ADDENDUM #2

ISSUED BY EDiS COMPANY
110 S. POPLAR STREET, WILMINGTON, DE 19801

RED CLAY CONSOLIDATED SCHOOL DISTRICT
A. I. DuPont Middle School
HVAC RENOVATION
3130 KENNETT PIKE
WILMINGTON, DELAWARE 19807

A-401

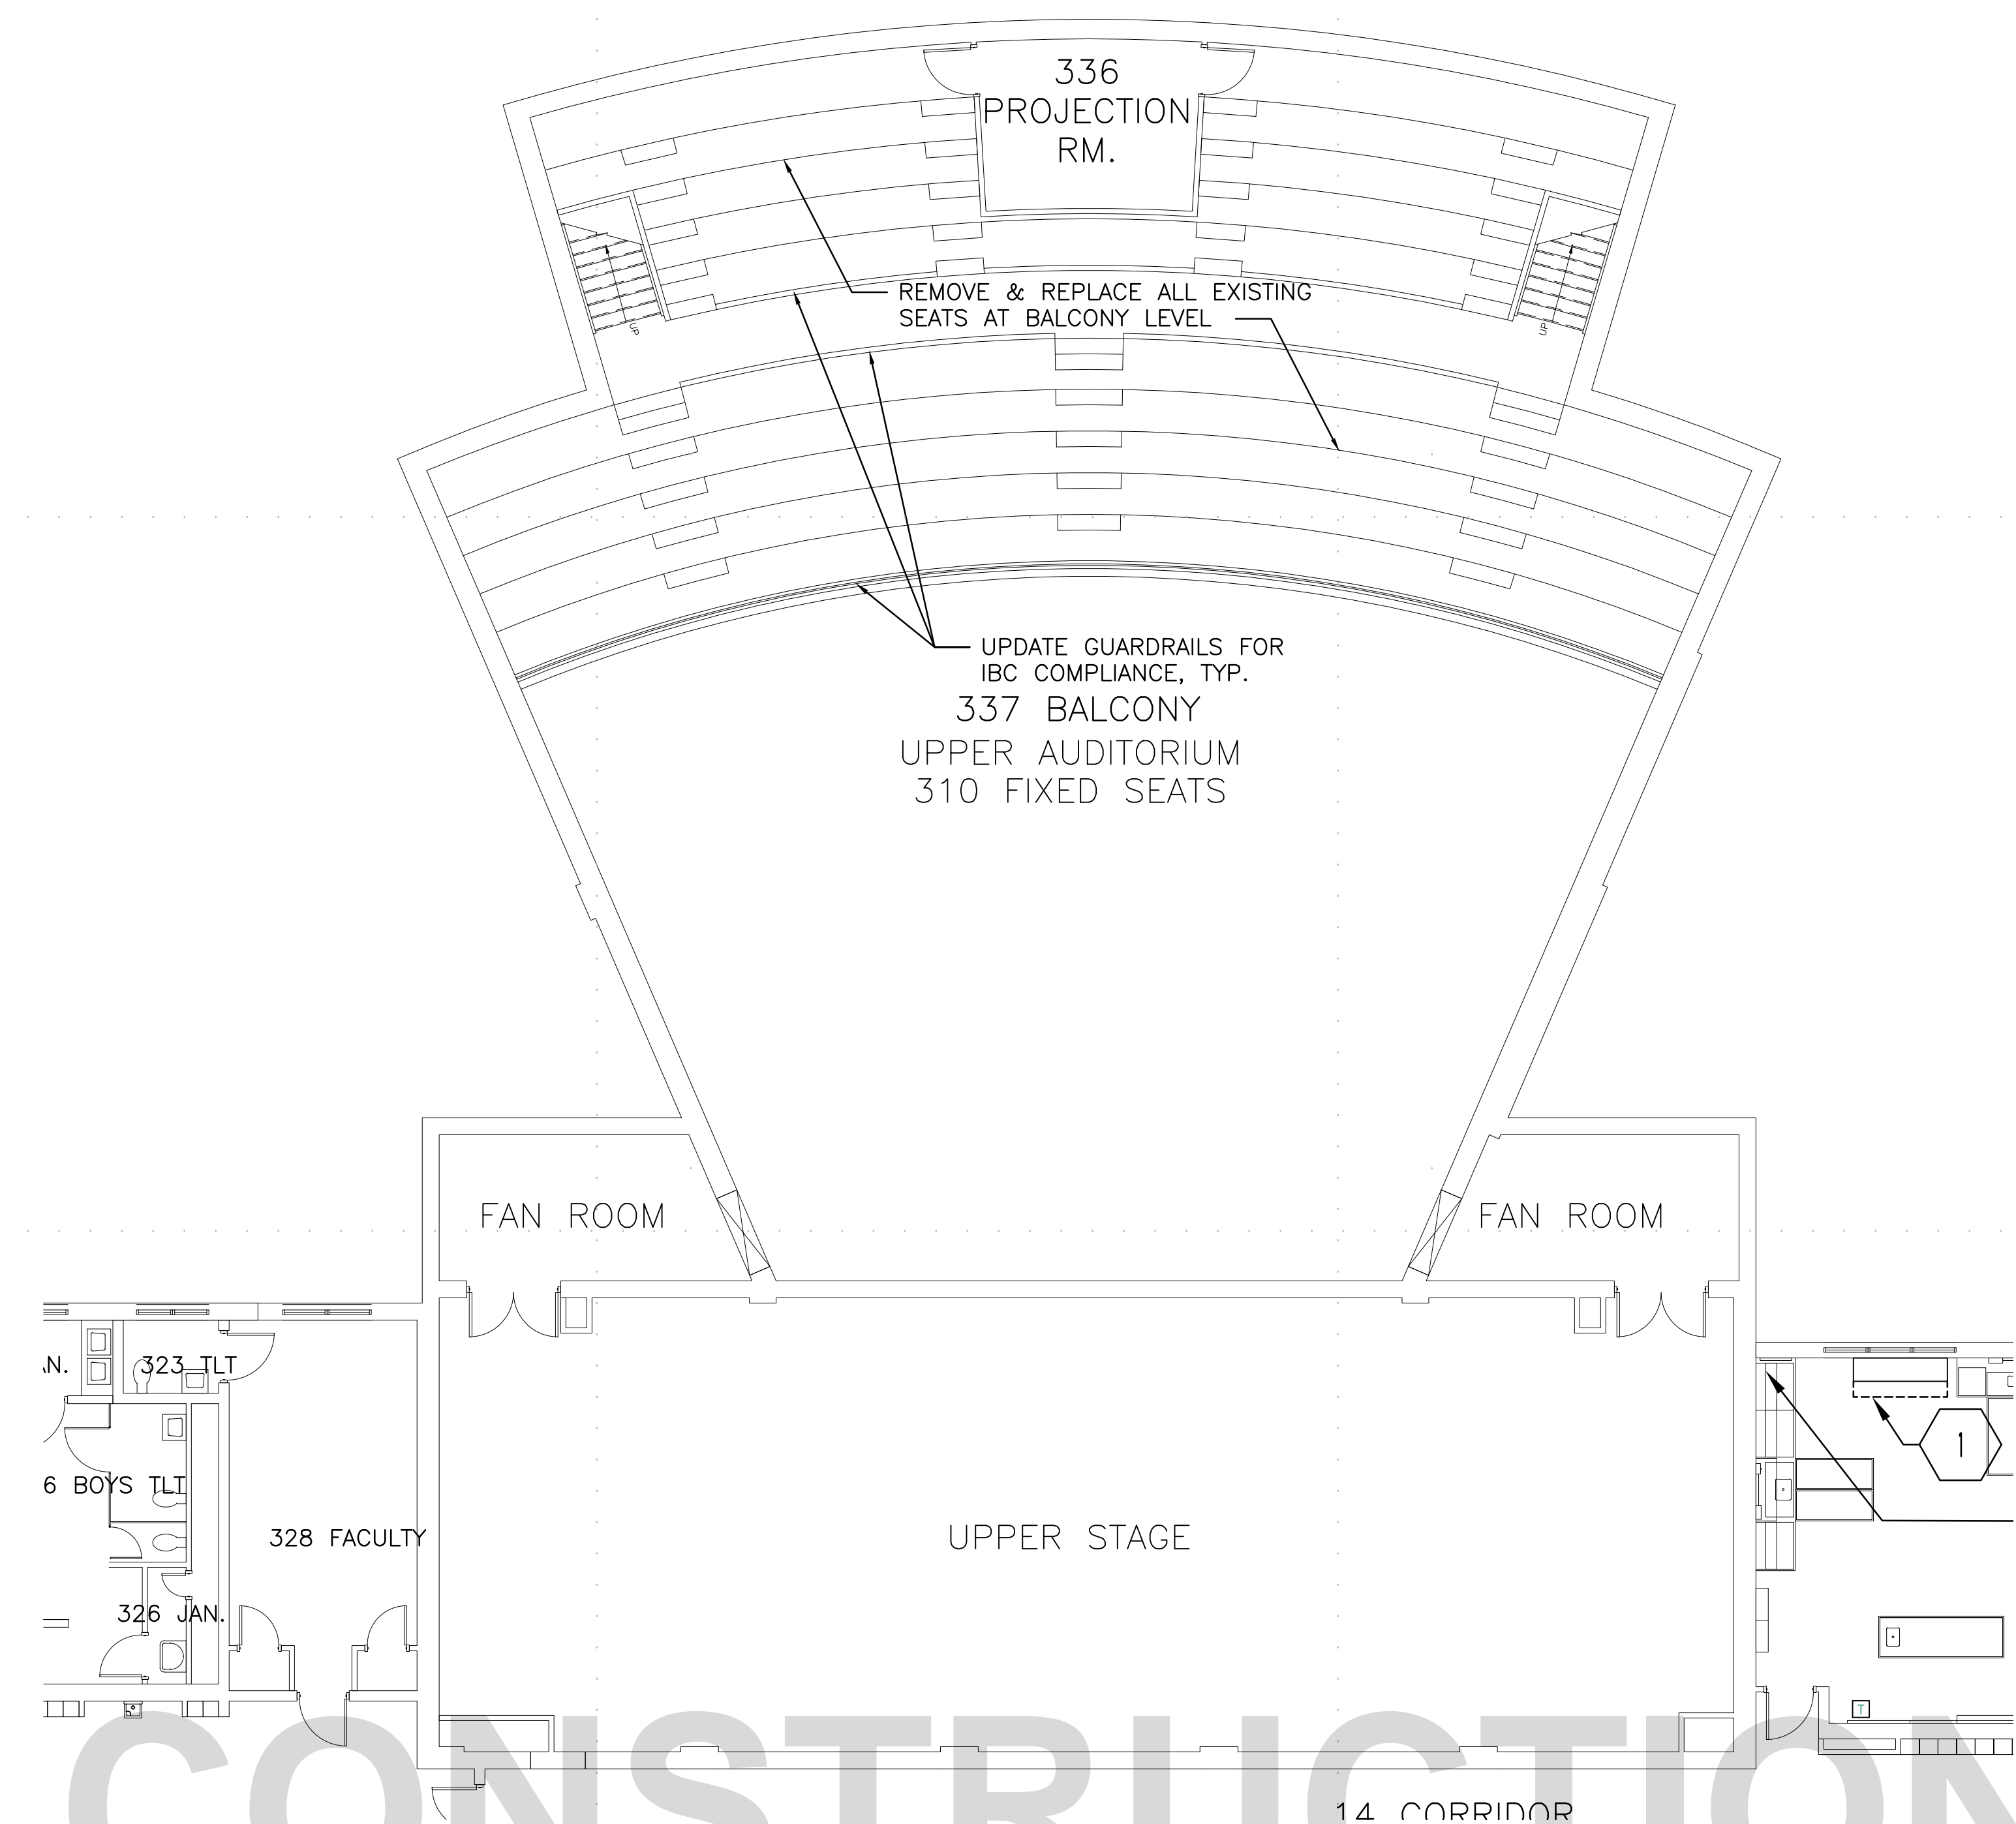
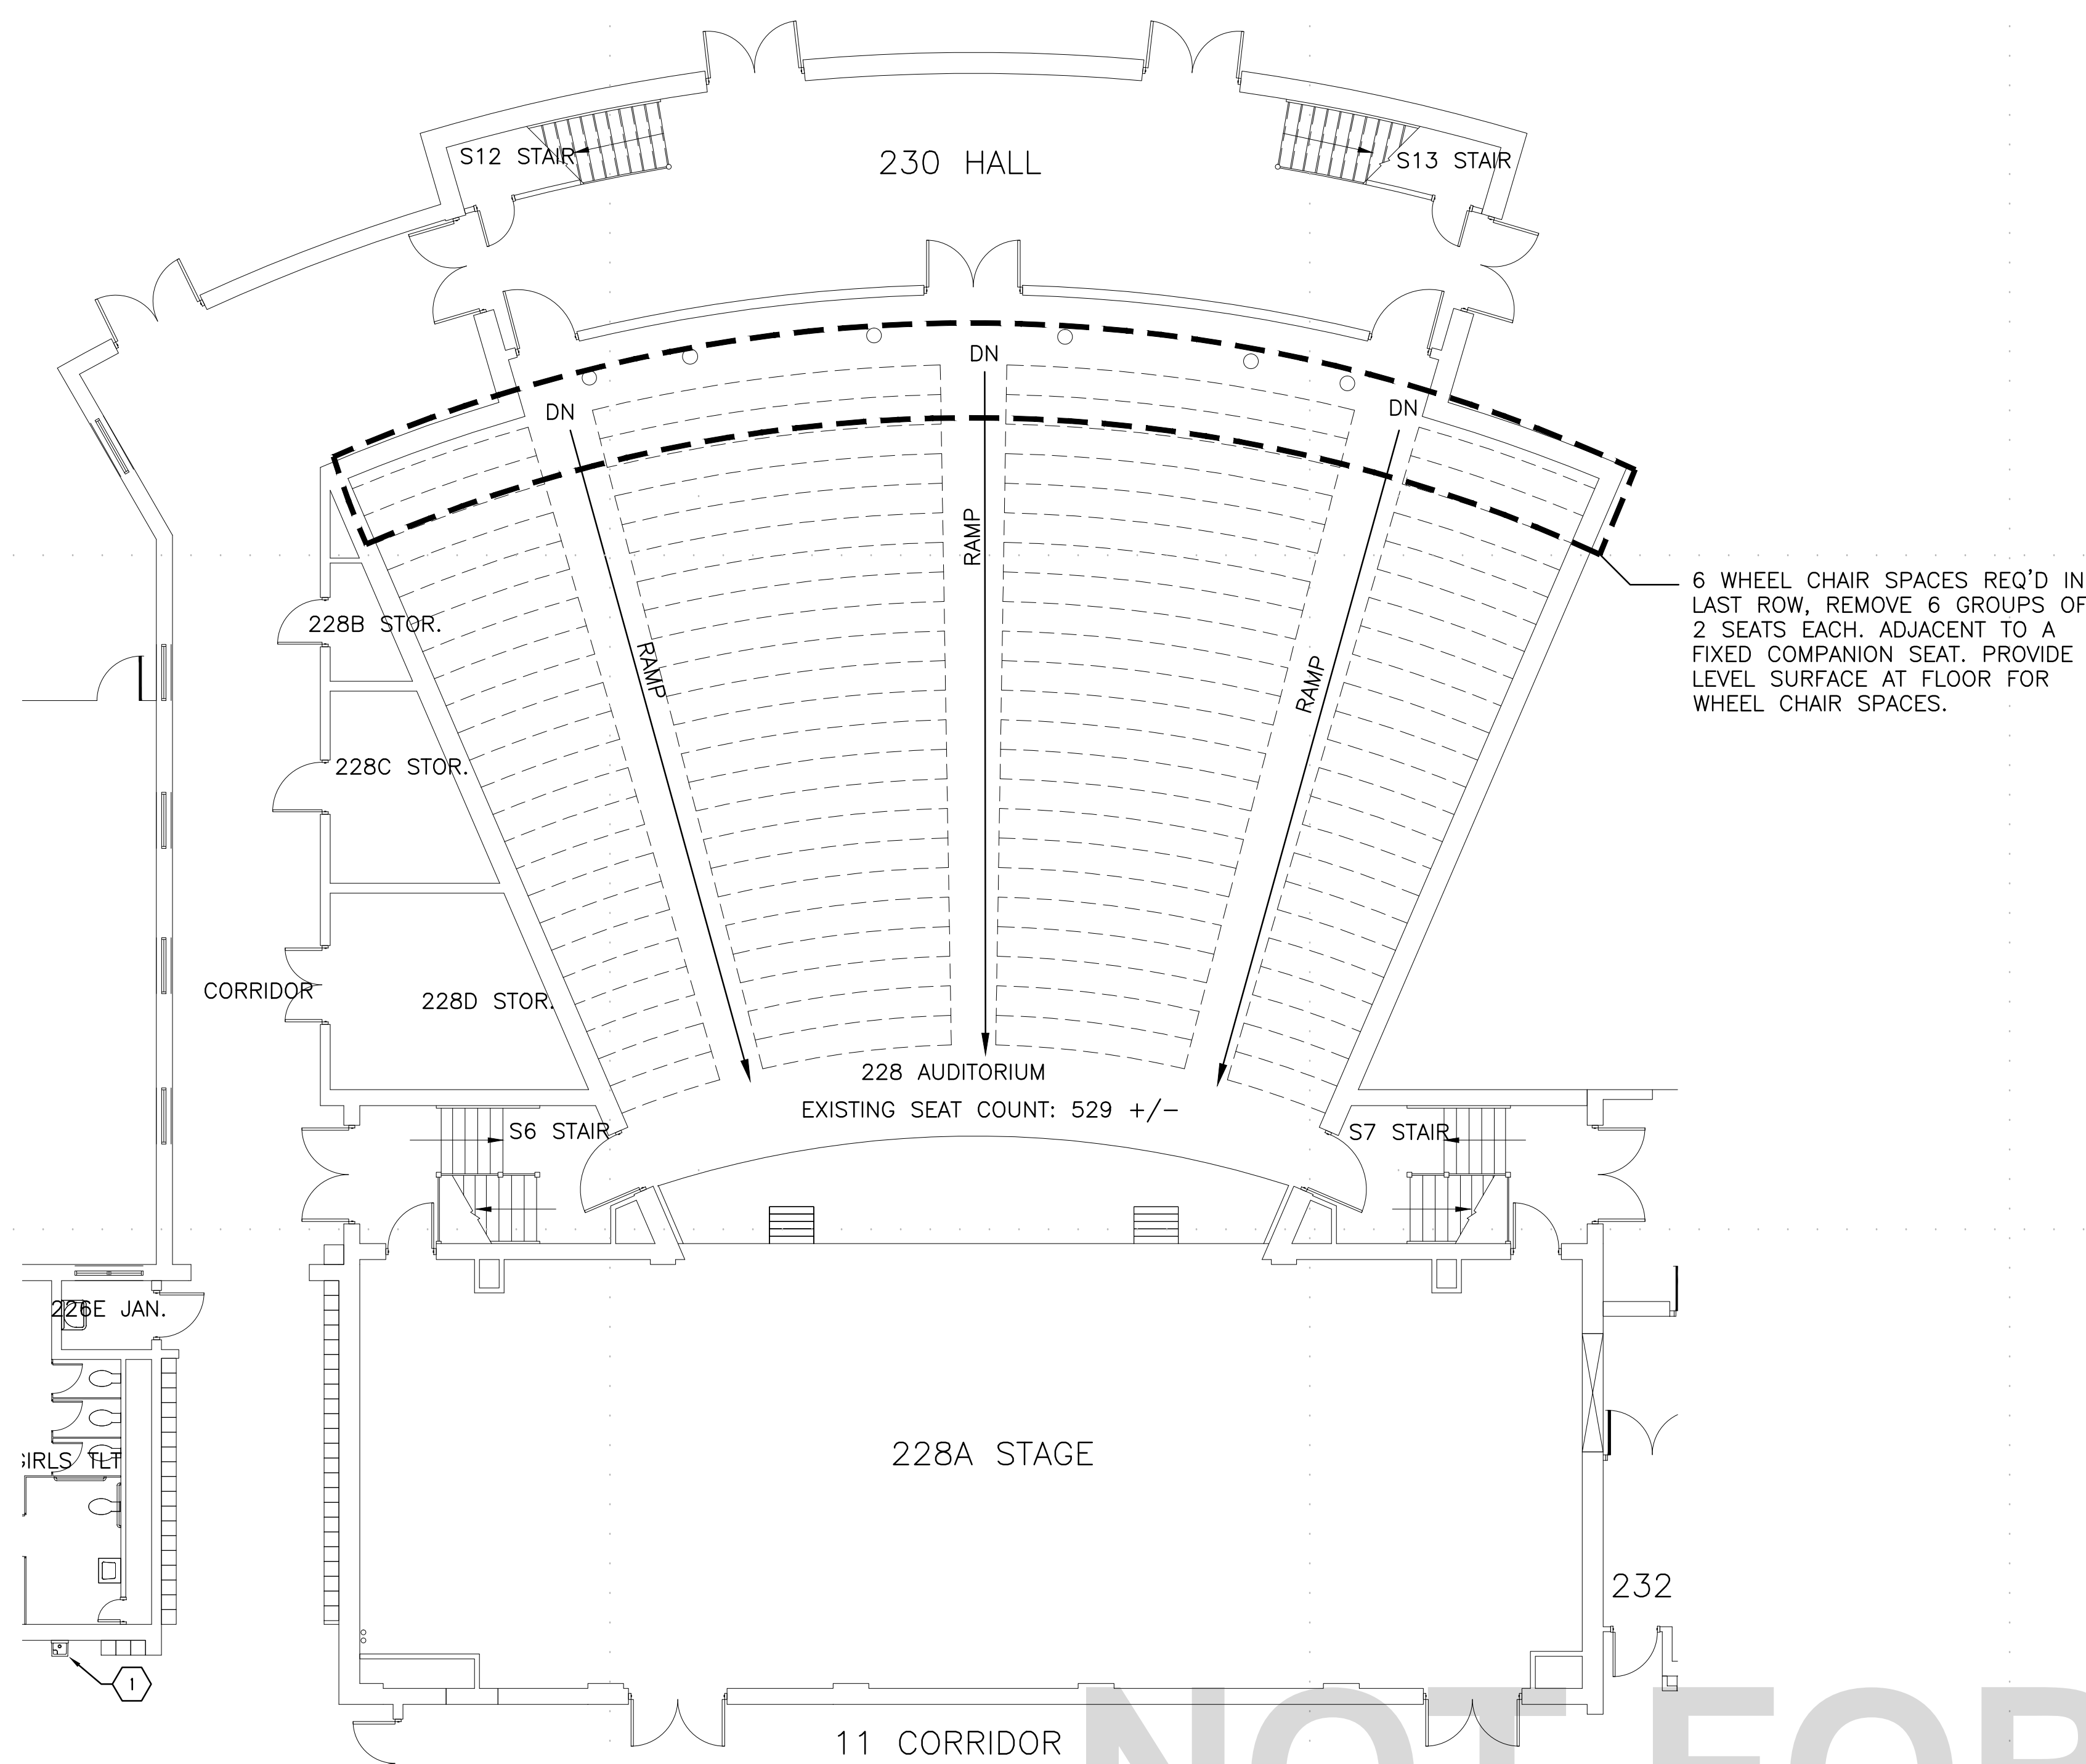
11. Alternate #4 covers Drawing A-401. I see a note that says "update guardrails for IBC compliance" but there are no details. Please provide more information. This might affect the carpentry package if the work involves miscellaneous metals (carpentry SOW item 80).

- a. **Drawings A-401, 402, and 403 were provided for the reference of Contract A-09 : Auditorium Seating only. Other items shown on these drawings including modifications to the guardrails is to be provided by the district.**

PARTIAL LOWER LEVEL REFLECTED CEILING PLAN - AREA A - 1/A3.7

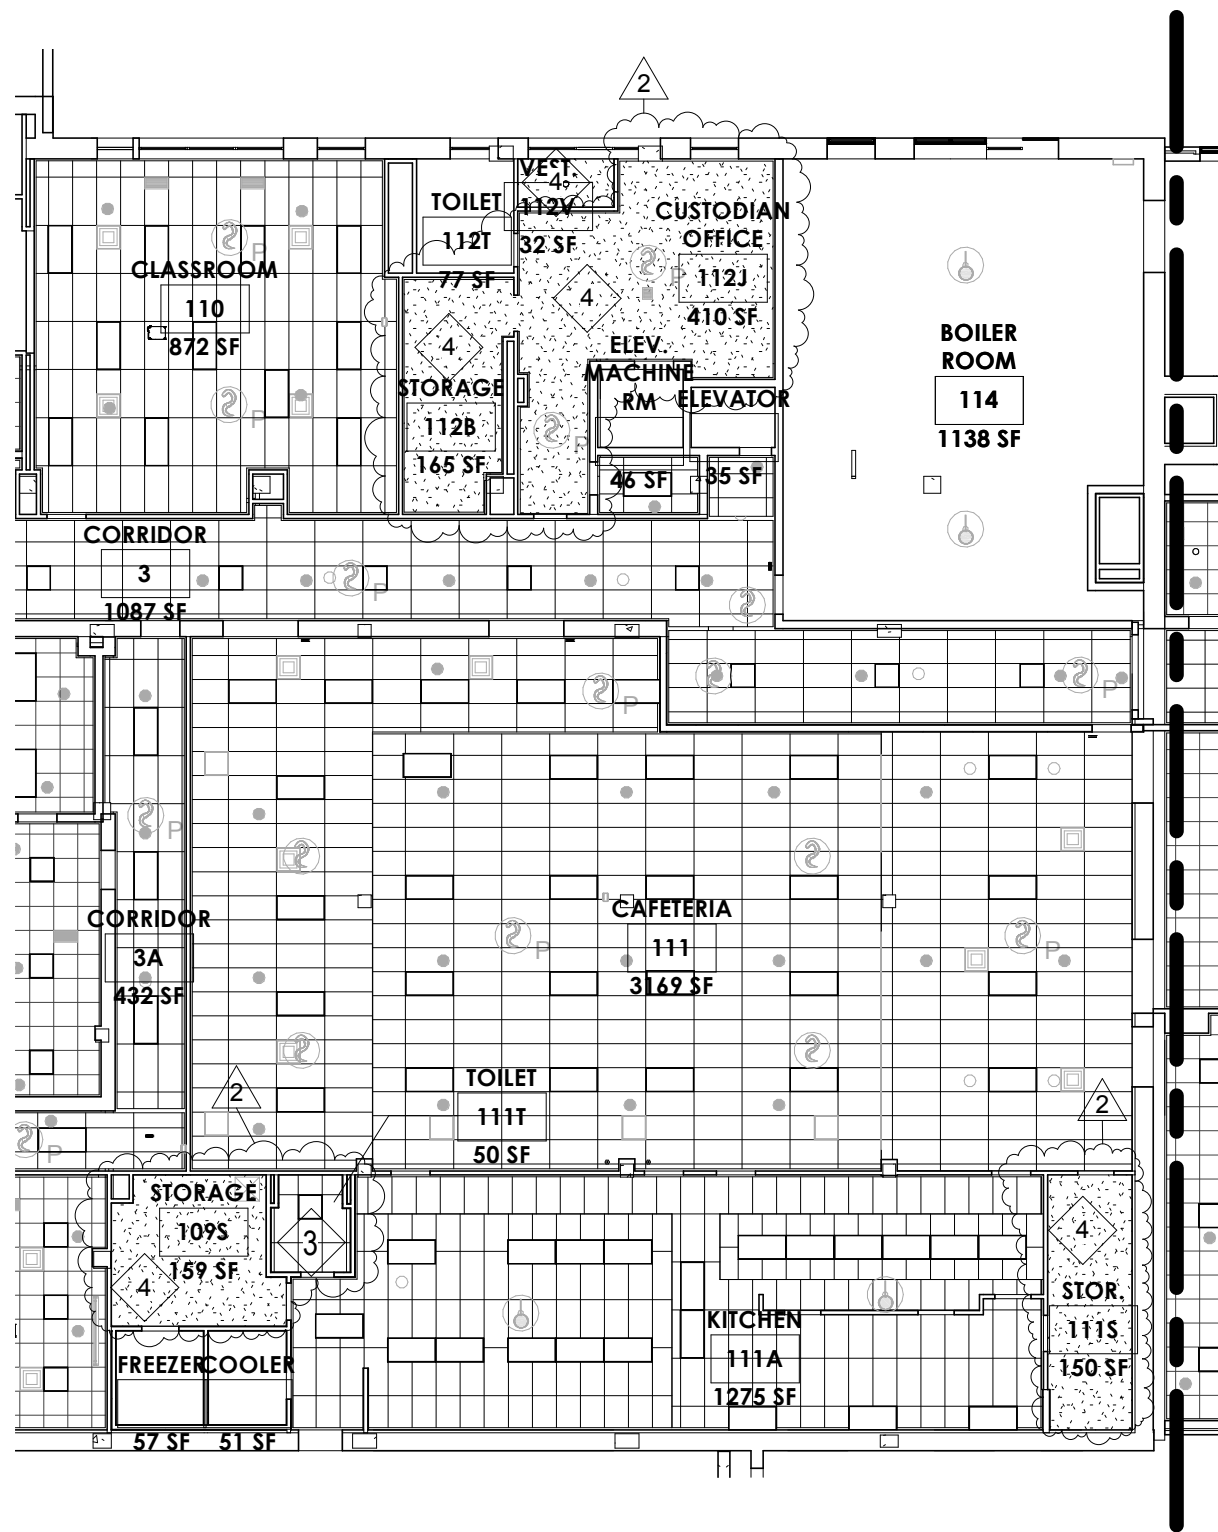
4. Drawing A2.7 – Additional ceiling demolition scope has been added. See attached sketch SK-A.26.
5. Drawing A3.7- Additional new ceiling installation scope has been added. See attached sketch SK-A.27.

3 EXISTING EIFS PANELS TO MATCH
SK-A.28

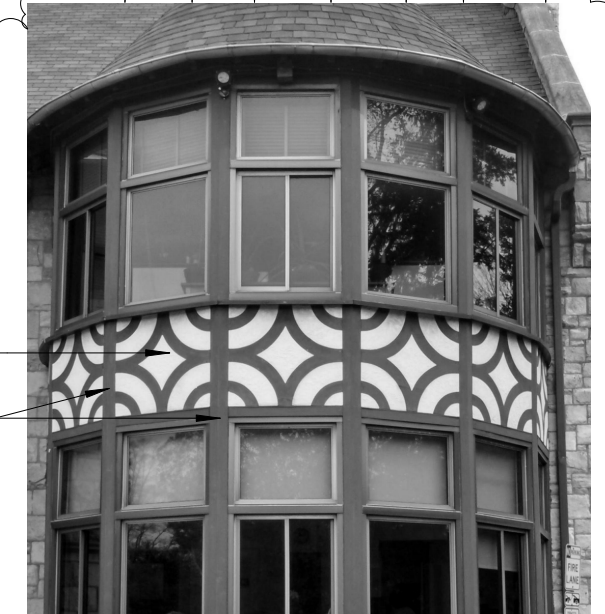
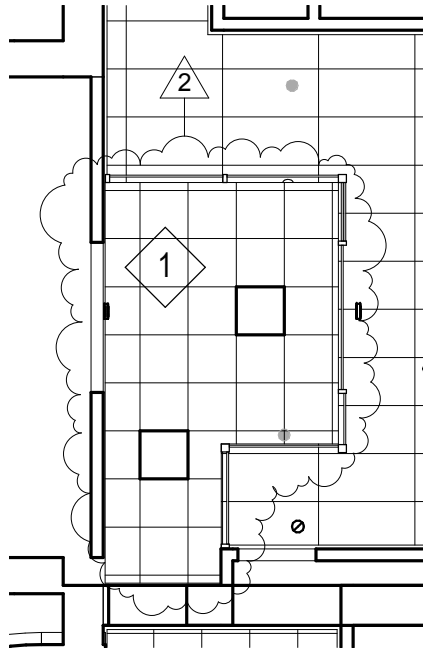
6. Drawing A3.1 – Demolition and new installation of EIFS panels at front exterior elevation. See sketch SK-A.28.
7. Drawing A6.1 – Sheet reissued with revisions to vents at Storefront Elevations. See attached sheet.

EXISTING EIFS PANEL SYSTEM (7 TOTAL) TO BE REMOVED AND REPLACED WITH NEW EIFS PANELS. NEW PANELS TO RECEIVE TWO-TONE FINISH COAT TO MATCH EXISTING PATTERN. SEE EXISTING PHOTO 3/SK-A.28 FOR EXISTING DETAIL TO MATCH. APPROXIMATE SIZE OF EACH PANEL IS 42" x 42", V.I.F.
